**Planning Commission - Subdivision Review Committee  
City and Borough of Juneau  
Paul Voelckers, Chairman**

May 19, 2015

Subdivision Review Committee Meeting - Tuesday May 19<sup>th</sup> 2015

Legal Description: Tract D of US Survey 1369

Background

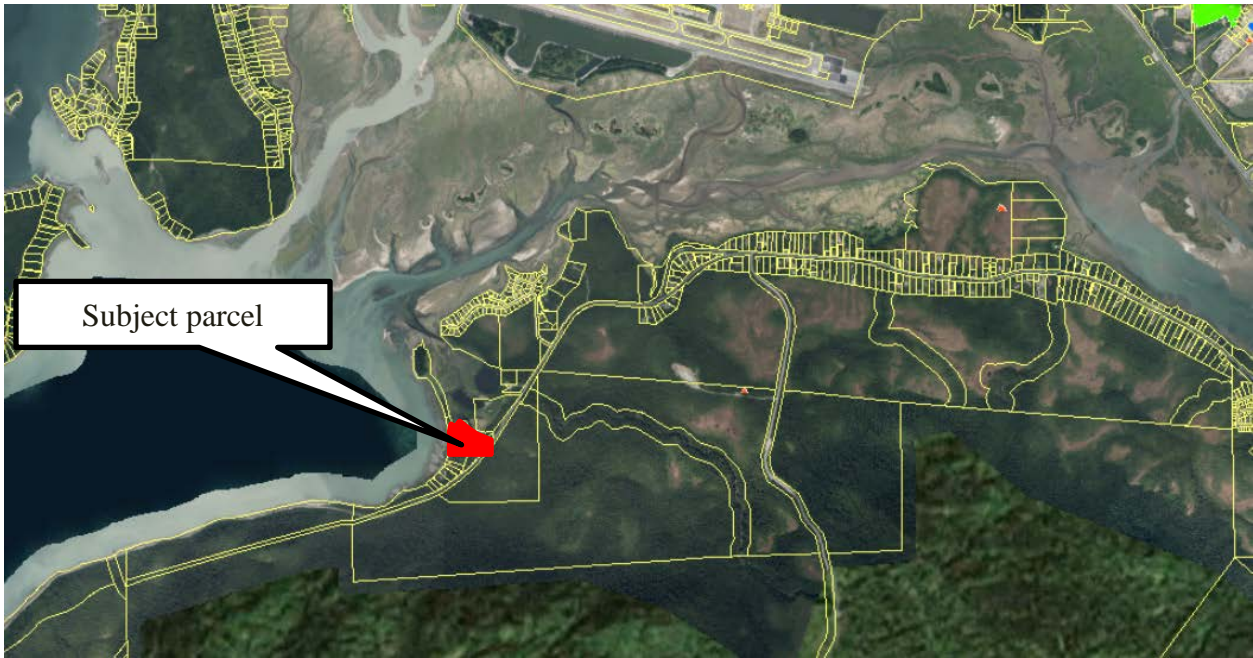
The subject lot (from now Lot A) surrounds a smaller lot (from now Lot B). The smaller lot has no road frontage onto the Right of Way. Both lots are owned by the same owner and this renders the easement along the driveway access to Lot B redundant as a property owner can not have an easement agreement with themselves. This lack of road frontage would have to be corrected as part of any future subdivision to return it to a conforming situation.

Lot A currently has just over 300ft frontage on to a Right of Way so two conforming, albeit very large lots, could be created with the minimum required width of 150ft. Access easements would be required if the current driveway were used for both lots.

- 1) **The creation of two lots that don't meet minimum front lot line width requirements that may require a variance.** The requirement of a variance would depend on the application of the Director's discretion. The application of this Director's discretion depends on the judgement as to whether there is difficult topography or other circumstances that render compliance impracticable.

- 2) **A dedicated Right of Way and the creation of two additional lots on the southerly portion of the property.** As this is outside the Urban Service Boundary, and the Annual Daily Trips would be expected to be below 250, the roadway would be required to be a 24ft wide gravel surface road with 60ft Right of Way dedicated to the City. This could run along the current drive way alignment. This would allow the possibility of more lots having road frontage in future and would not require a variance. Feedback from DOT would be necessary.

In both proposals presented, the existing, isolated Lot B would be expanded to include the accessory improvements currently situated on Lot A. Depending on the use this may be unnecessary since Storage in a Garage/Barn would be allowed as a use in its own right in a Rural Reserve zone according to the Table of Permissible Uses) if the storage is less than 10,000sq ft.

All proposed lots would provide a minimum 150-foot square within the lot boundaries. The Realtor has indicated that in the long term, the a road would be required to develop the large remainder parcel to the north because of the ratio of available land to available road frontage. However, at present, the owners preference would be for approval for the new lot along the southerly border without the expense of improving the current driveway i.e. they would wish for Proposal 1. Fire regulations may require some upgrade of this driveway.

The Realtor has suggested that the extensive wetlands in the area at southeast corner of Lot A would likely be too expensive to sensibly develop that lot shown on Proposal 2. The owners are not overly concerned about losing the opportunity to create this additional lot. Staff also advises against creating a lot that is exclusively wetlands.

#### Areas for consideration

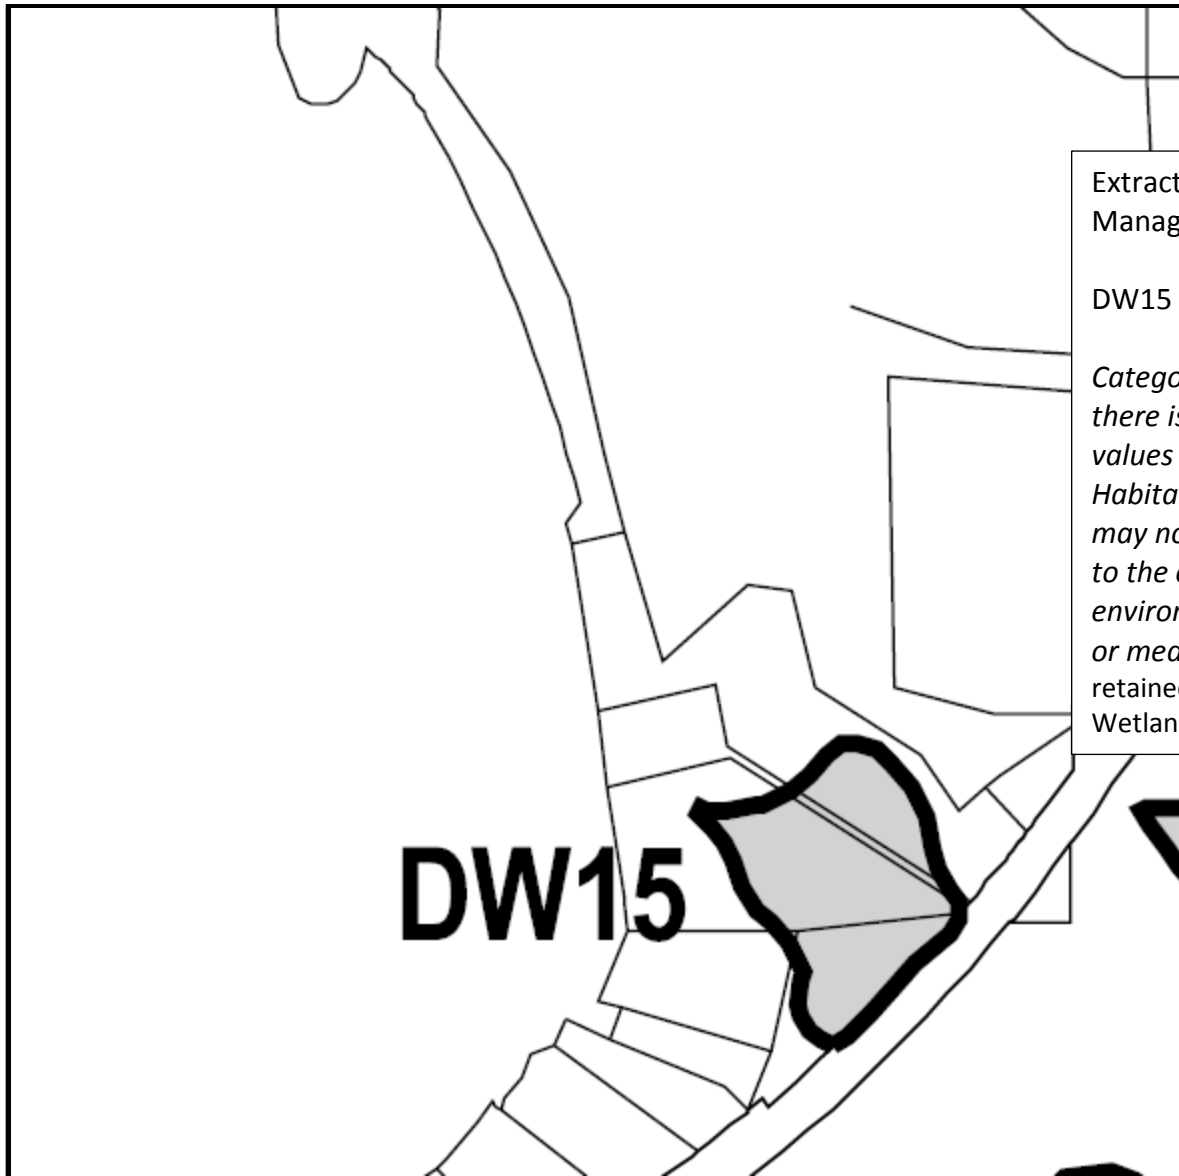
Staff has identified the following issues to be addressed as part of any proposal:

- **150ft of road frontage** would be required for lots in Rural Reserve (measured at the 25ft setback) for no variance or Director's discretion to be required.

- All lots are required to have **30ft of road frontage** or a variance is required.
- **Variations and easements** may be required depending on the number of lots being created as this affects the location of driveways and any lot width.

- **Existing Wetlands** (see attached Wetlands Map) could make it difficult to construct on parts of the current Lot A. Understanding the scale of this cost and wetland management implications would aid a decision as to whether the Director's discretion is applied or provide a supporting case for a variance. Staff recommends that not lots are created that are entirely wetlands. A wetlands delineation may be required to determine the actual location and extent of any wetlands.

- The **driveway configuration** for both proposals should be described. Access to all lots via one driveway or Right Of Way on to N. Douglas Hwy is probably required by DOT. In both proposals access driveways may require fill permits unless the access proposal in the VAR20090019 is implemented.

- For a variance to the minimum lot width to be unnecessary, the Director's discretion, 'minimum rectangle' approach would have to apply. There should be a case presented that highlights 'topographical or exceptional circumstances' that prevents subdivision using a conforming configuration.

- Depending on the existing **uses** on Lot B the owners may need to expand Lot B to encompass the barn and other accessory buildings as part of the subdivision? Storage in a building of less than 10,000sq ft is allowed on a lot in its own right in a Rural Reserve zone.
